Access Compliance Report Public Rights-of-Way (Curb Ramps)

Main Street: N_ESPLANADE_ST		Cross Street: SPRING_ST		Location:	NE
ADA ID: RPAT210927113106	Ramp Type:Type 1 - Perpendicular	Initial Pass/Fail: Fail	Overall Compliance: No	Severity Score:	30

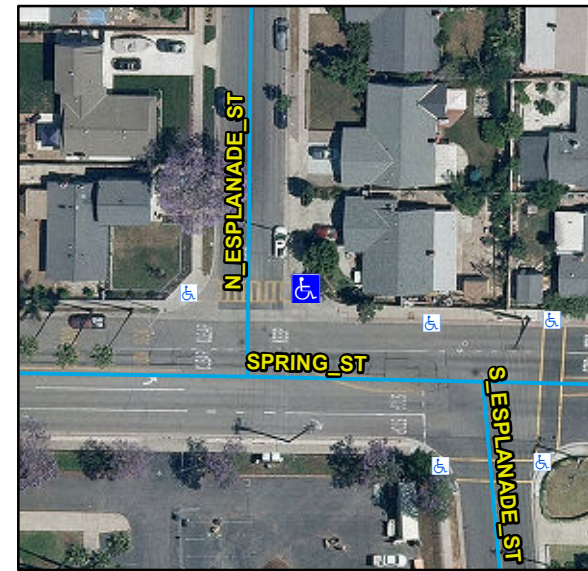
Compliance	Description	Data	Compliance	Description	Data
N/A	Ramp Length (in)	87	N/A	Flare Type LT	
Yes	Ramp Width (in)	54			N/A
No	Ramp Run Slope (%)	14.6	N/A	Flare Slope LT (%)	N/A
Yes	Ramp Cross Slope (%)	1.2	N/A	Flare Traversable LT	N/A
N/A	Landing Present	N/A	N/A	Flare Type RT	
N/A	Landing Length (in)	N/A			N/A
N/A	Landing Width (in)	N/A	N/A	Flare Slope RT (%)	N/A
N/A	Landing Run Slope (%)	N/A	N/A	Flare Traversable RT	N/A
N/A	Landing Cross Slope (%)	N/A	N/A	DWS Provided	N/A
N/A	Landing Movement Obstructed?	N/A	N/A	DWS Contrast	N/A
	Landing Movement Type	N/A	N/A	DWS Length (in)	N/A
N/A	Landing Shared	N/A	N/A	DWS Full Width	N/A
N/A	Clear Space	N/A	N/A	DWS Offset Left (in)	N/A
N/A	Clear Space To Crosswalk (in)	N/A	N/A	DWS Offset Right (in)	N/A
N/A	Marked Crosswalk 1	Yes	N/A	Marked Crosswalk 2	N/A
	Crossing 1 Direction	W		Crossing 2 Direction	N/A
	Marked Crosswalk 1 Width (in)	120		Marked Crosswalk 2 Width (in)	N/A

Remove & Replace Entire Ramp.

R304.2.2, STD 1115
